## SERVICE BULLETIN

**SB016-0025**

Subject: Main Gear Door Hinge Service Issue

Evolution Main Landing Gear Hinge & Bolt Replacement

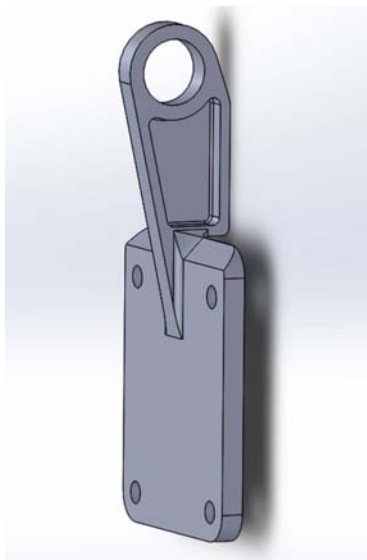
The hinge(s) connecting the main gear door on some Lancair Evolution aircraft have been shown to crack, warp or fail. This can result in issues with the main gear door function. Some aircraft have also experienced issues with the AN3 bolts which attach the gear door lower link to the main landing gear trunnion. Lancair has redesigned the gear door hinges to add greater strength margins in addition to specifying a stronger bolt for the link. These four hinges are to be replaced on all Evolution main gear doors.

Picture 1

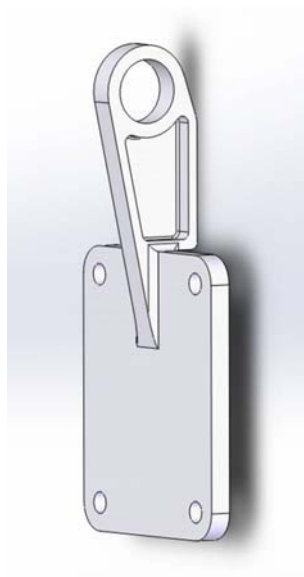
The main landing gear hinge has had two versions with different hole locations. You will need to determine which hinge is currently installed. Below are pictures of the two hinges that are currently in service. Please compare these pictures to the hinge on your aircraft. Replace the small link-to-trunnion attach bolt on each gear leg as well.

Picture 1 shows a chamfer at the end of the hinge, whereas Picture 2 shows a square edge. Once you identify the hinge needed, please contact Lancair at 541-923-2244 and ask for our parts department to order the proper hinge & bolts.

Part Number and Description		Quantity
Picture 1	150-0027 Hinge Inboard Main Landing Gear Door, Chamfer	4
Picture 2	150-0027C Hinge Inboard Main Landing Gear Door, Square	4
	101-0251 Bolt, Main Landing Gear Door to Trunnion Linkage Ref. 9-10 Rev 4	2
